Town of Duanesburg  
Zoning Board Minutes  
June 21<sup>st</sup>, 2022  
**Final Copy**

**TOWN OF DUANESBURG ZONING BOARD OF APPEALS  
RESOLUTION ISSUING INTERPRETATION OR IN THE ALTERNATIVE  
APPROVING AN AREA VARIANCE TO ALLOW EIGHT FEET TALL FENCES  
AT THE OAK HILL SOLAR PROJECTS**

Re: Public Hearing Oak Hill Solar 1, LLC and Oak Hill Solar 2, LLC fence height variance

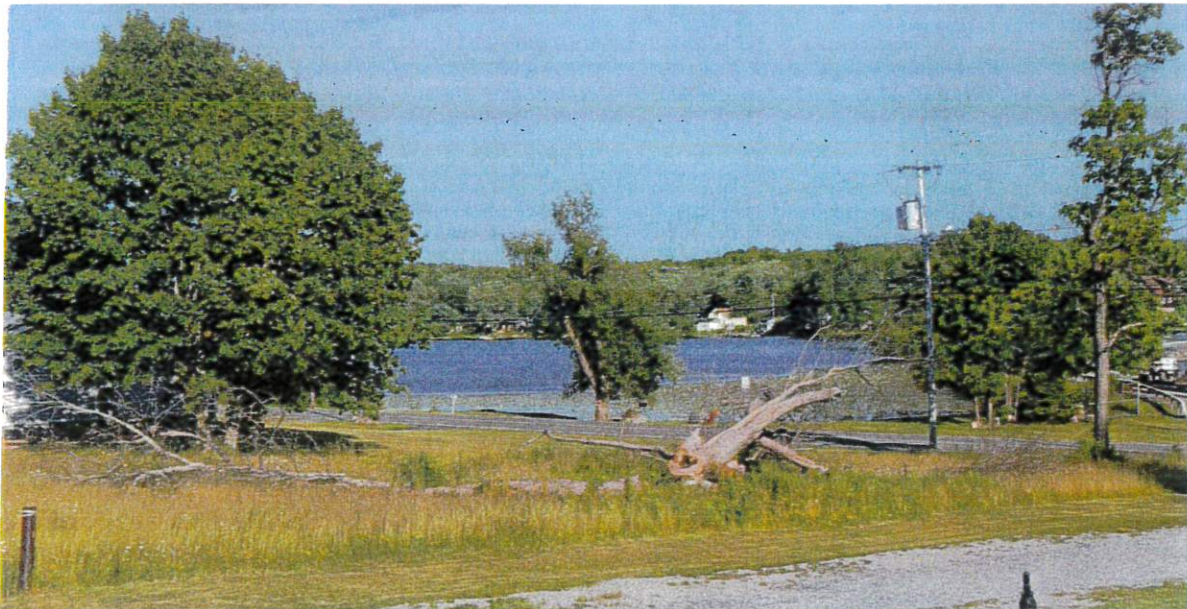
Position of the house to the West of 2610. Note the angle of the house which was done for the views of the lake.

View from the west side. Note that both sides of the lake are in view.

Current view. Placing on home in this area will completely block the view.

Unobstructed view of both sides of the lake.

**PROPOSED SITE PLAN FOR**  
**OAK HILL SOLAR 1&2**  
APPLICANT: OAK HILL SOLAR 1, LLC / OAK HILL SOLAR 2, LLC  
TOWN OF DUANESBURG, SCHENECTADY COUNTY, NEW YORK  
Tax Map No. 74.00-2-5  
1 of 10  
PLANS PREPARED BY: **edp**  
ENGINEER: **edp**  
DATE: 09/27/19  
SHEET: 11 OF 10

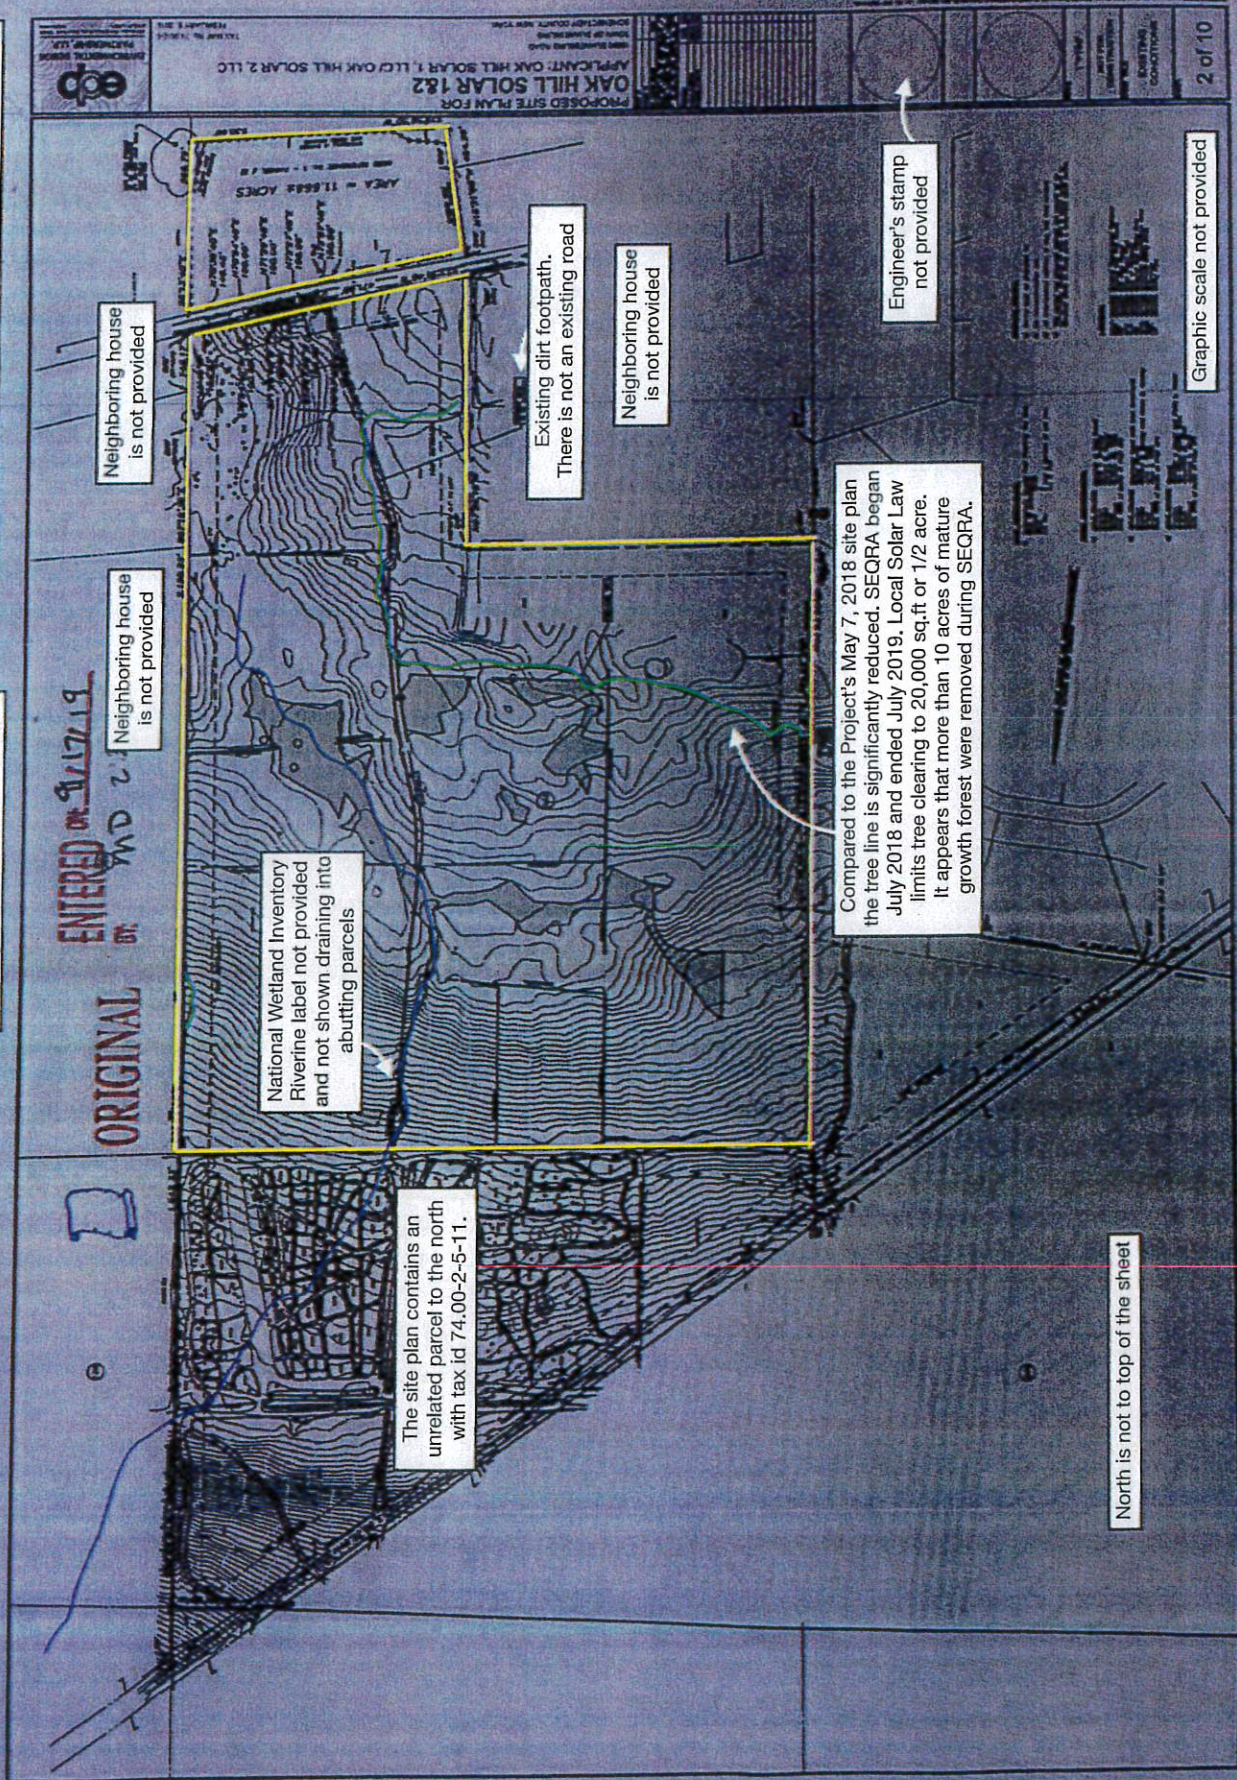
Sheet 1 of 10: A scale is not provided, graphic scale is not provided, includes unrelated tax id parcel to the north, abutter's houses are not provided, locations of 200+ tracking motors are not provided, engineer stamp is not provided.

Site Plan omits September 5, 2019  
Sheet 11, Landscaping Plan.

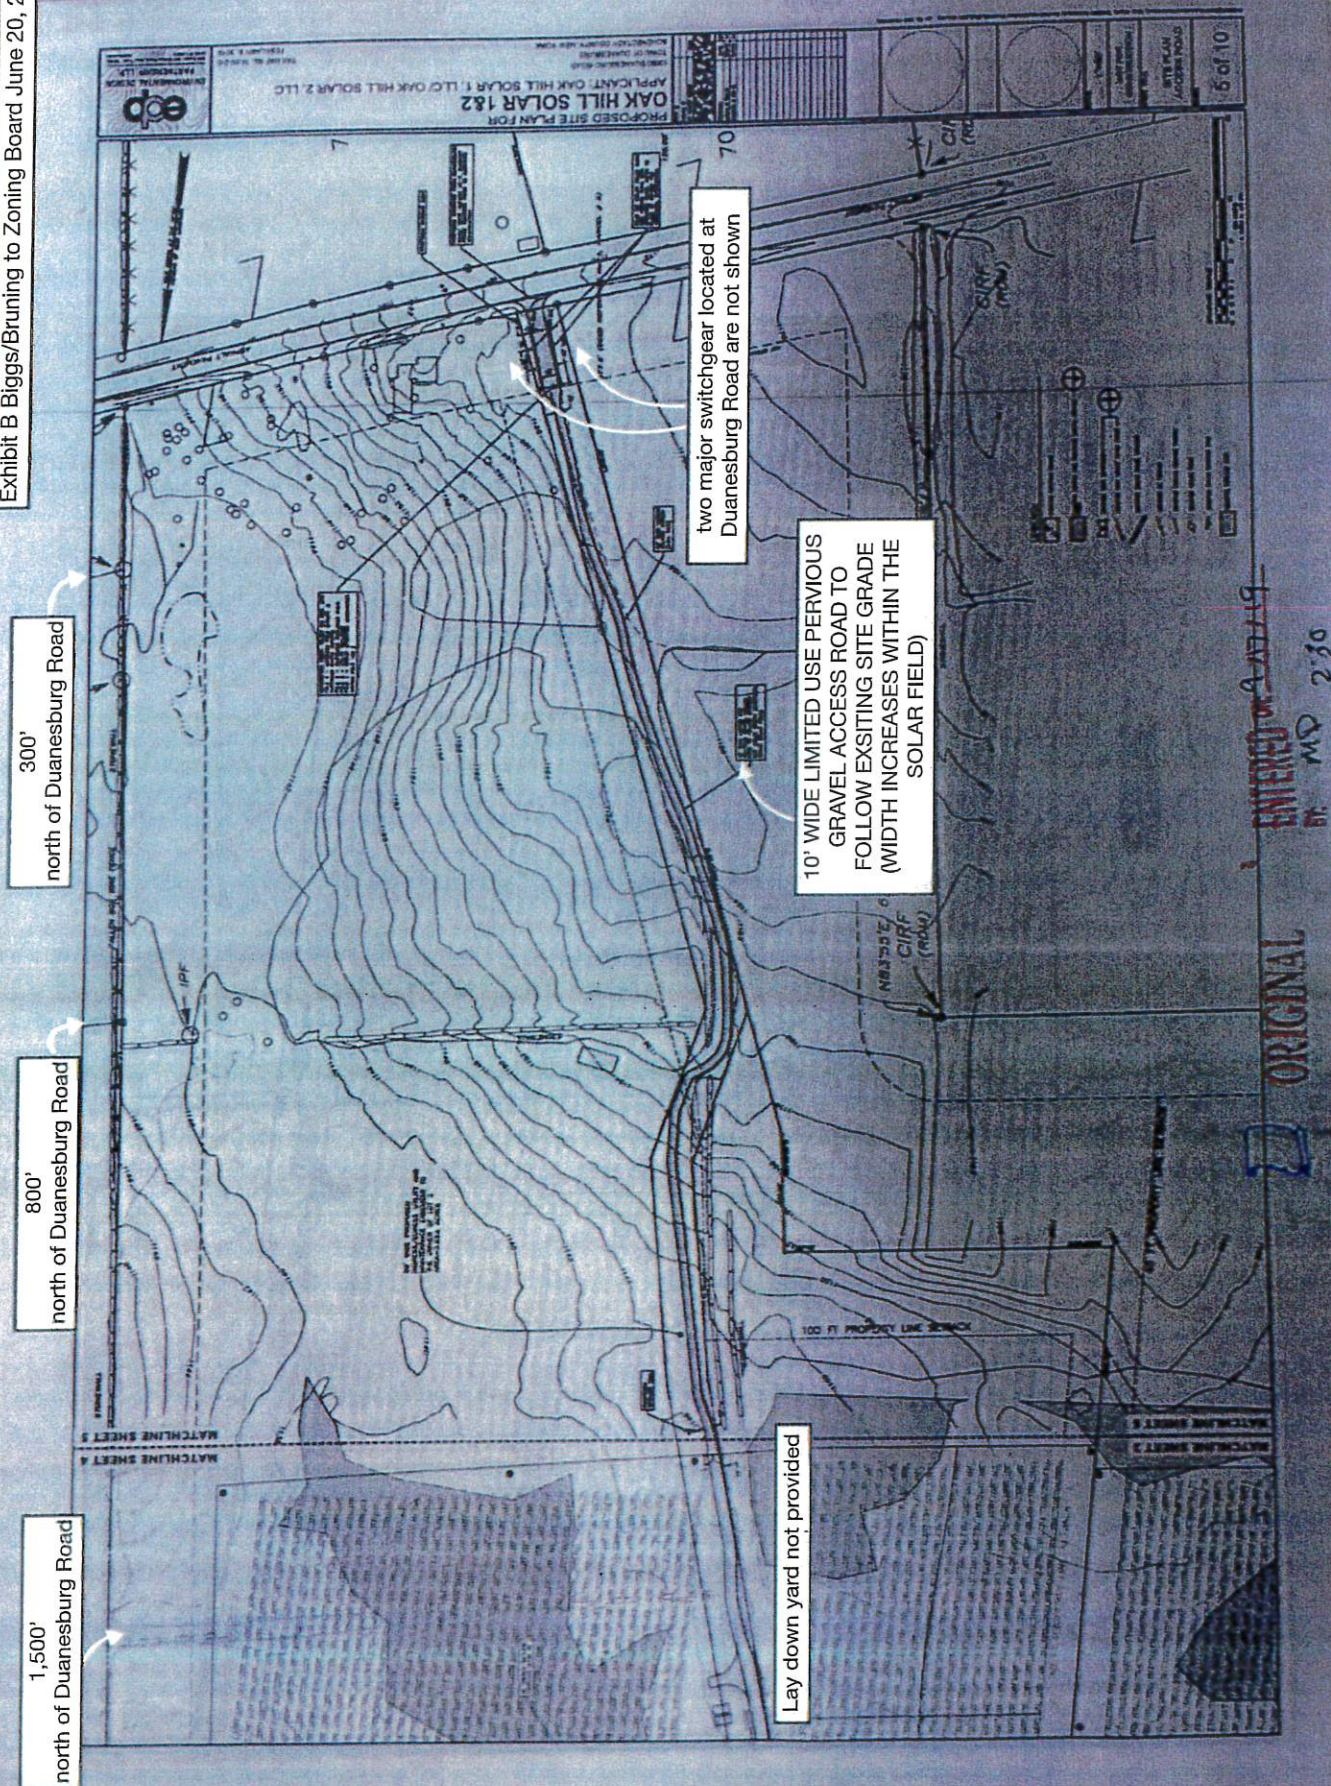
Image is not centered on the page

800'  
north of Duaneburg Road

300'  
north of Duanesburg Road

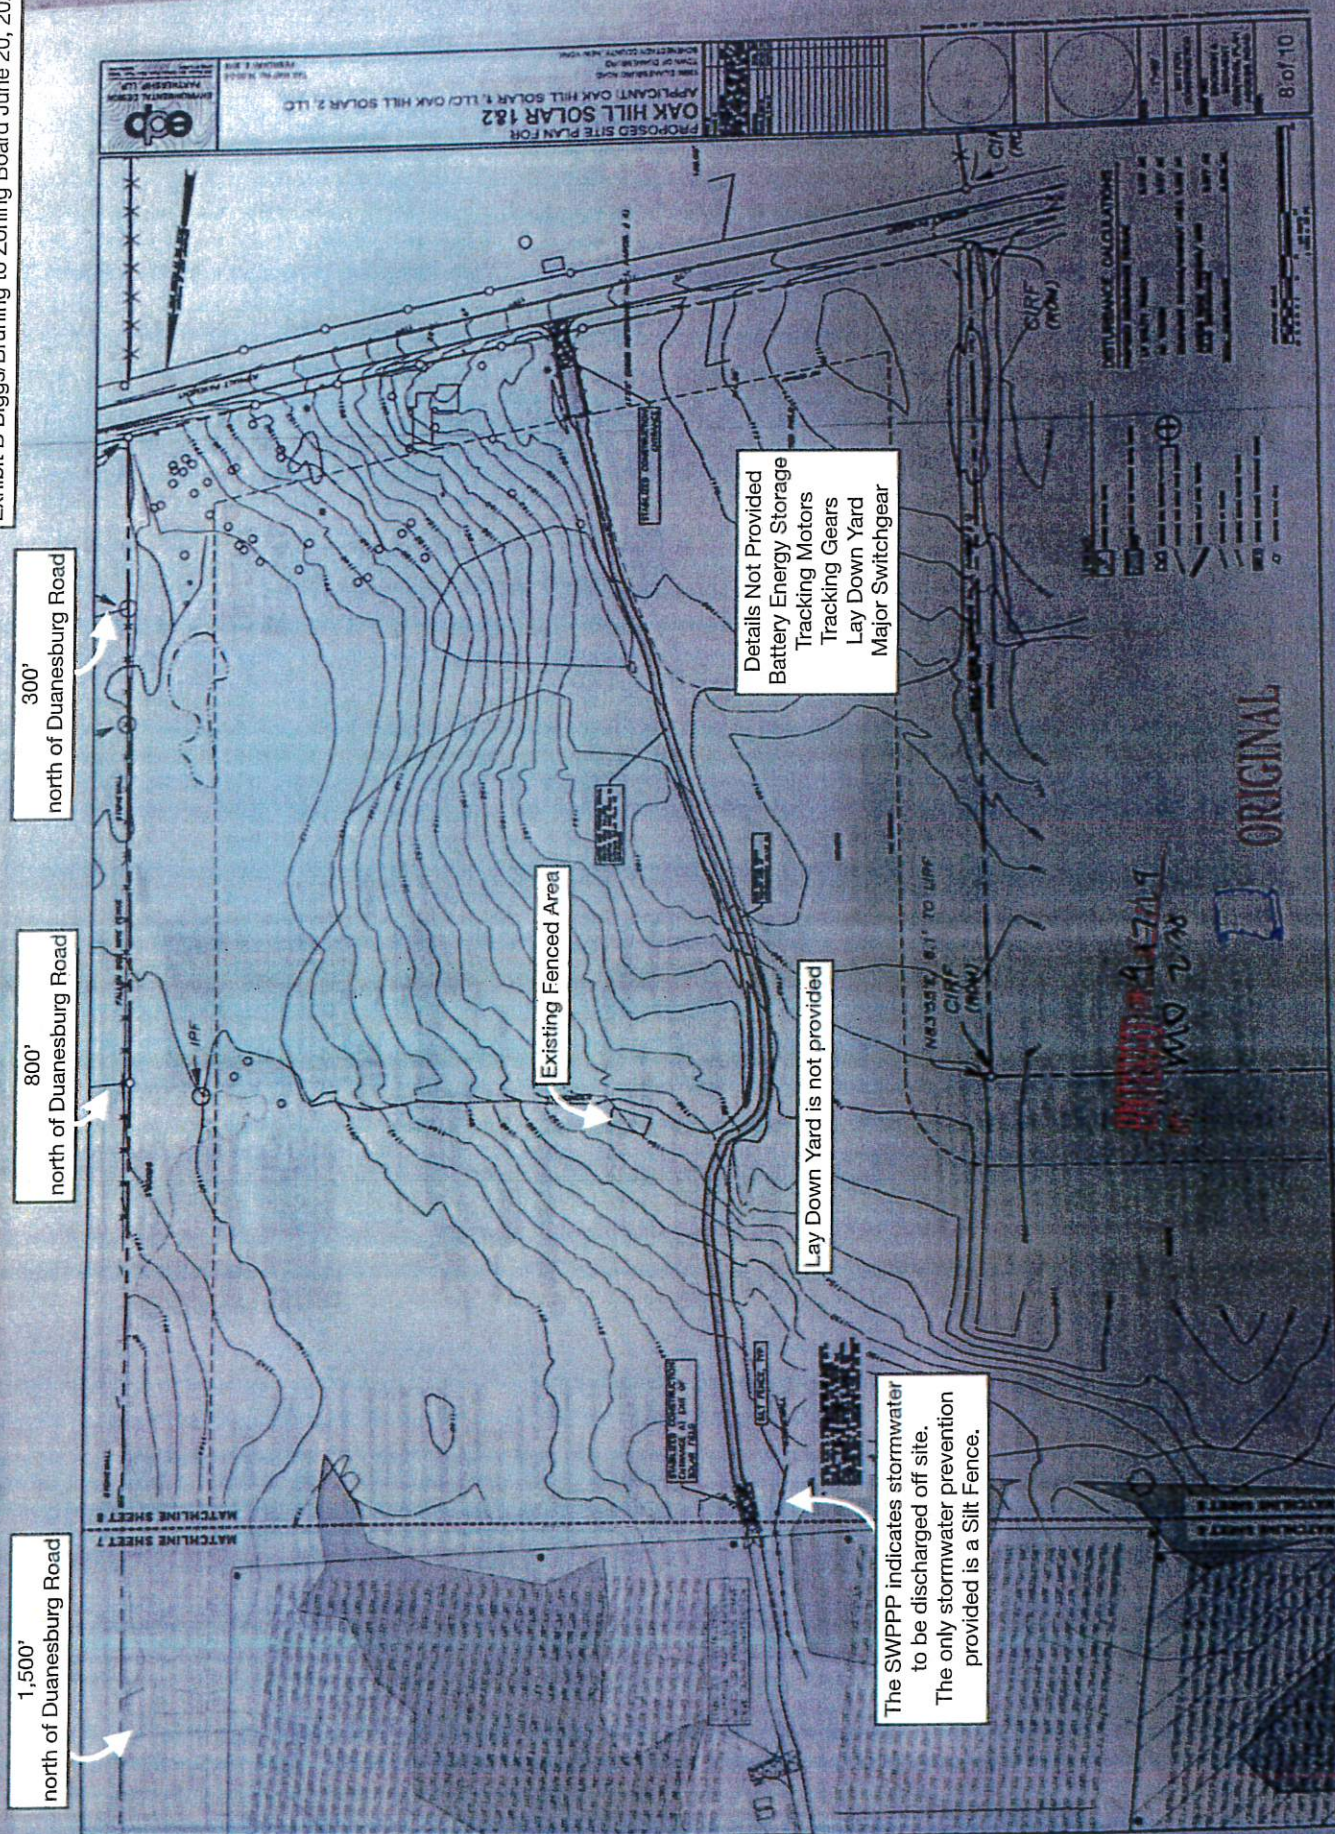
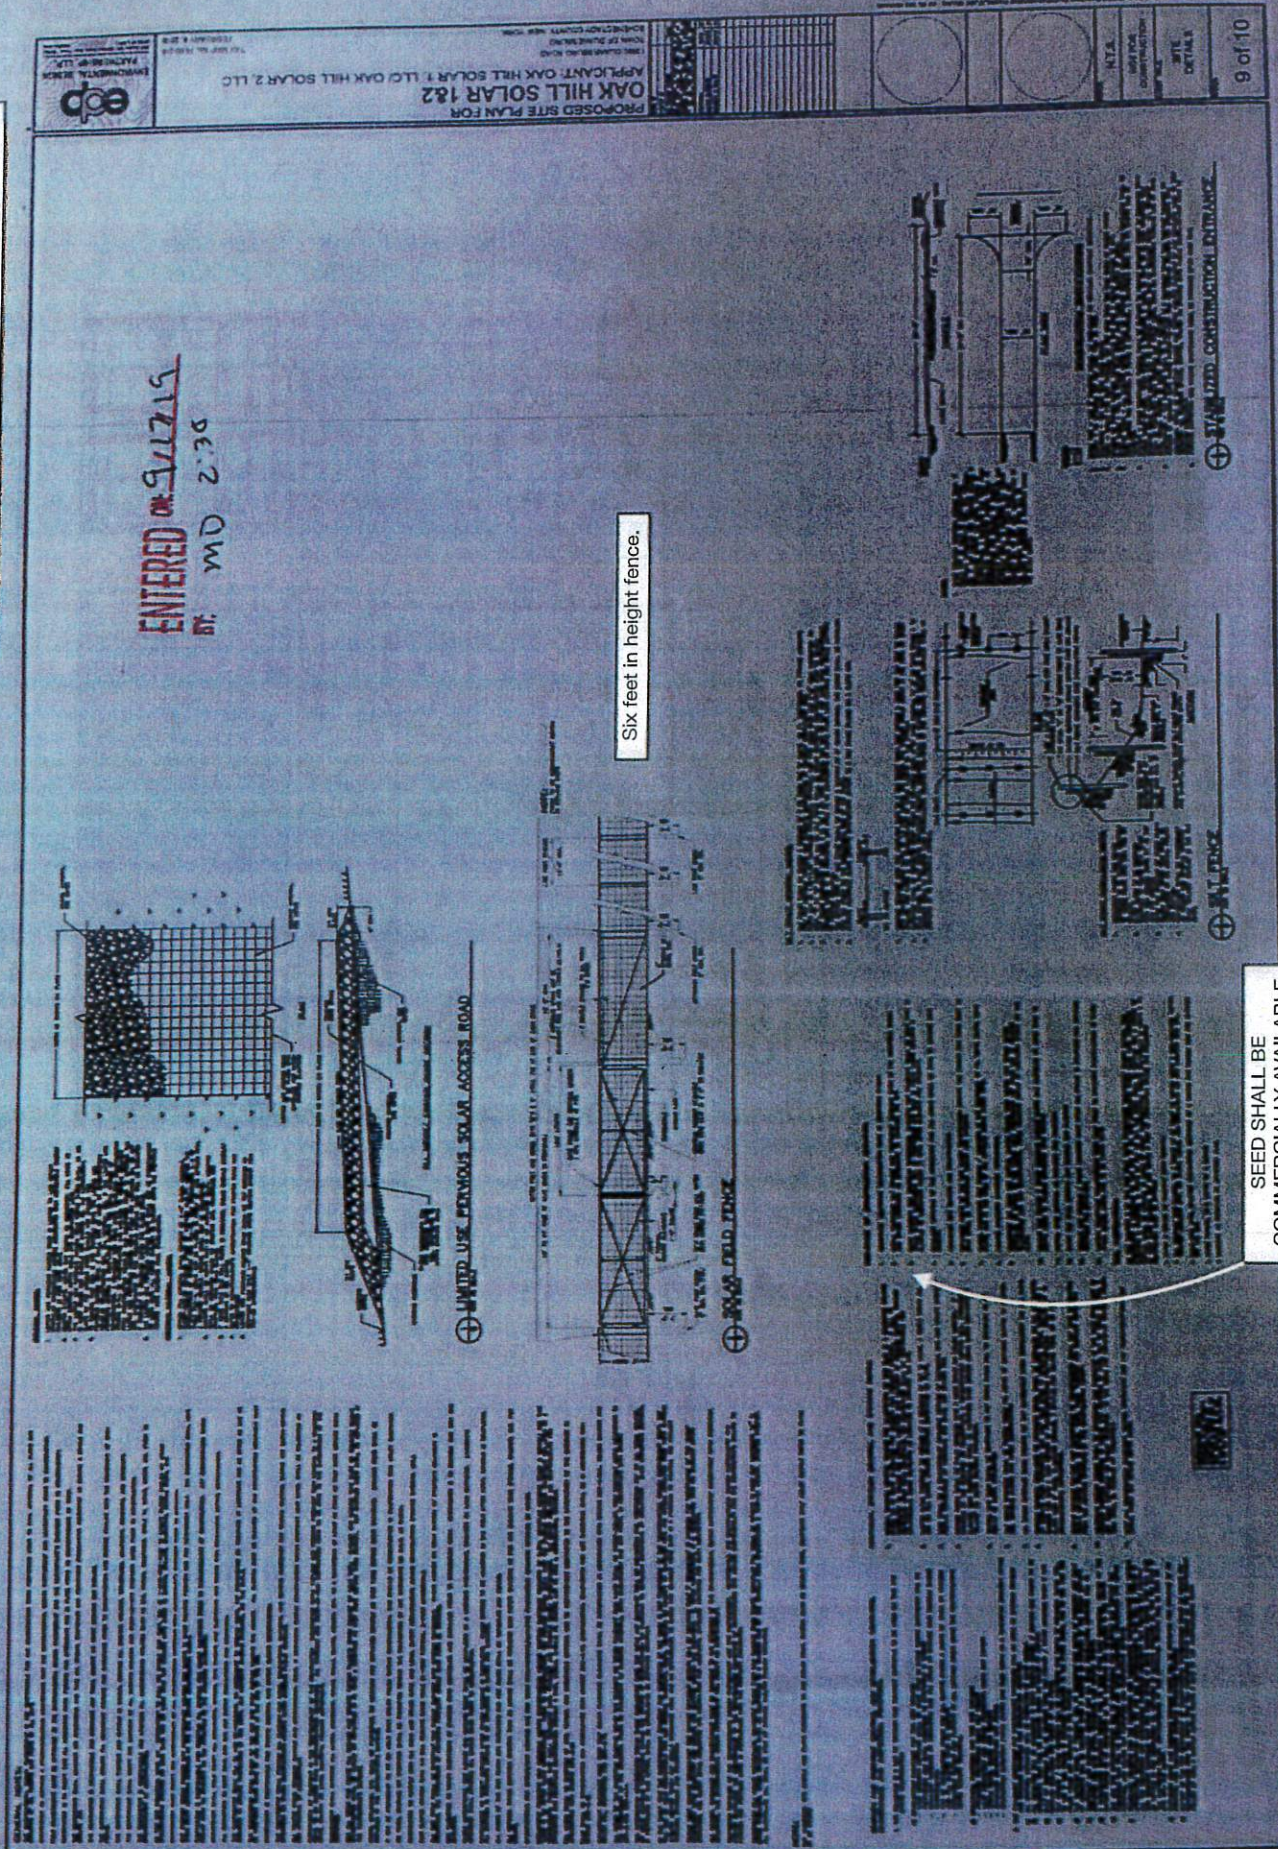
Electrical drawings not provided

Tracking panel system drawings not provided

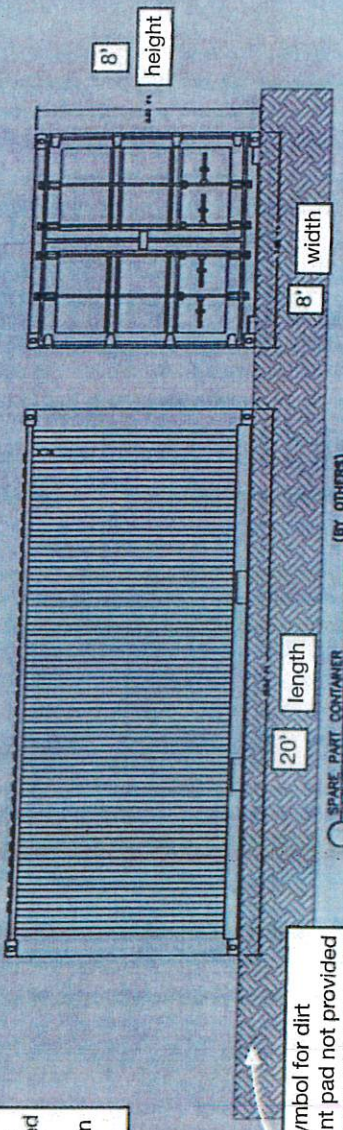
Wire is not in conduit.  
Wire may not be removed  
at decommissioning.  
Wire coatings are known  
to contain PFAS.

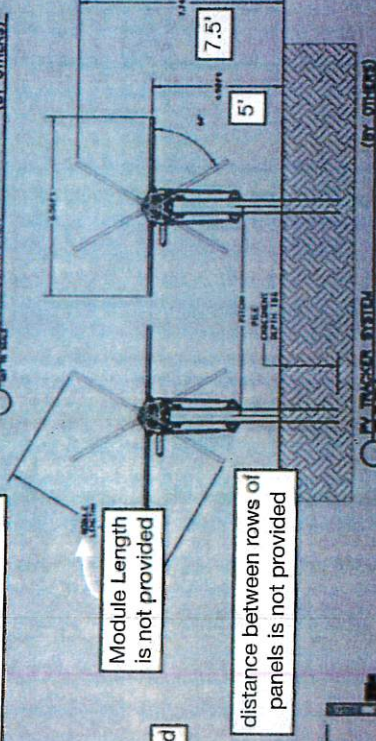
symbol for dirt  
equipment pad not provided

Module Length  
is not provided

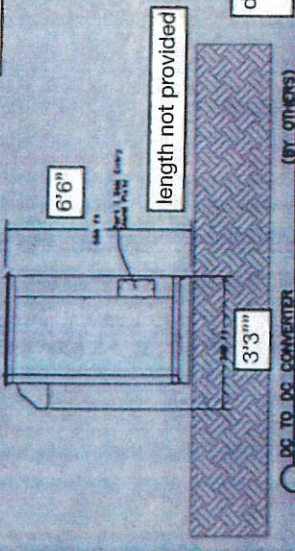
distance between rows of  
panels is not provided
